<b>PLAN 3</b>	<b>DRAFT AMENDMENT 02/15 – AMEND THE HERITAGE CODE AND THE HERITAGE PRECINCTS SPECIFIC AREA PLAN</b>
---------------	--

**PLANNING APPLICATION P16-018**

**Planning Application P16-018 - Additional Information Required**  
**23-lot subdivision in 3 stages & cul de sac (from 3 lots) (Bushfire prone area & attenuation distance) at 7-21 Paton Street, Longford**

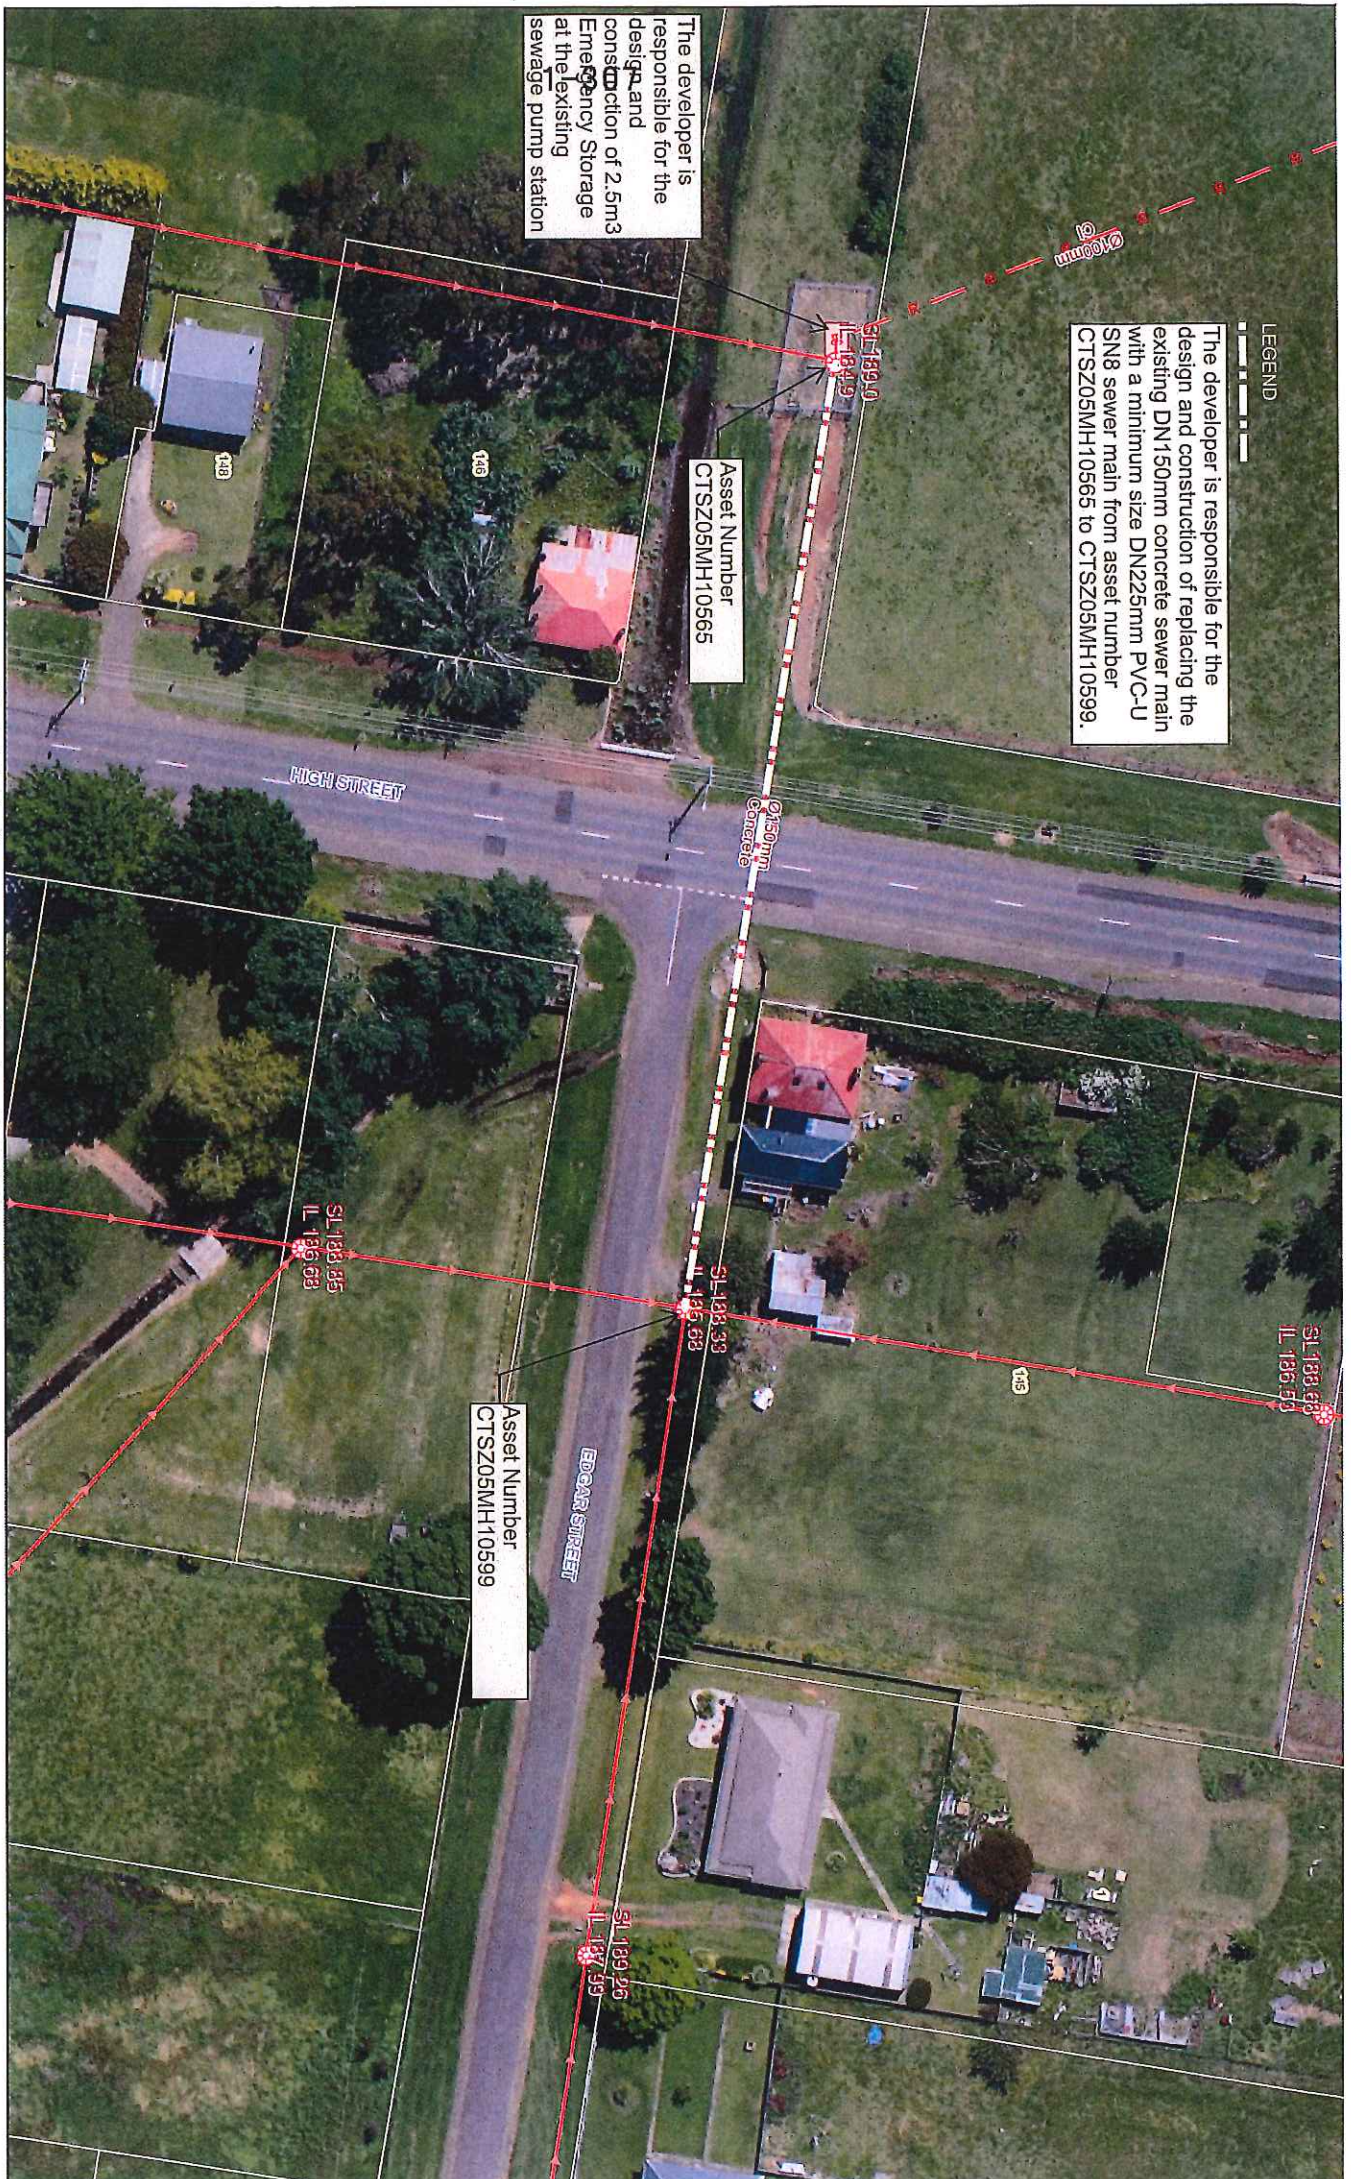
The developer is responsible for the design and construction of replacing the existing DN150mm concrete sewer main with a minimum size DN225mm PVC-U SN8 sewer main from asset number CTSZ05MH10565 to CTSZ05MH10599.
